Access Compliance Report

Public Rights-of-Way

(Pedestrian Signals)

Intersection ID: N/A	Main Street:	Cross Street: N/A	Location: N/A
ADA ID: 24F2A6BB15C4	Signal Type: One Push Button-Non APS	Overall Compliance: No	Severity Score: BTN 1: N/A BTN 2: N/A No BTN: N/A
Codes/Mitigation Info/Possible Solution		Field Measurements/Component Compliance

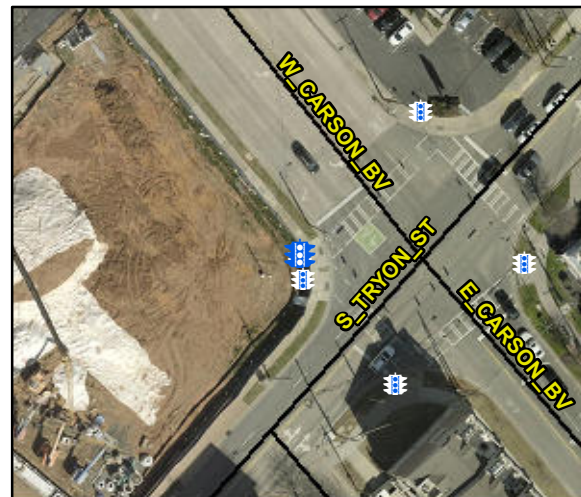
Possible Solutions: Replace Signal Push Button With APS Button on New Post. Remove & Relocate Sign.

PROW/ADA: TMUTCD 4e.08, R404.2, R404.3
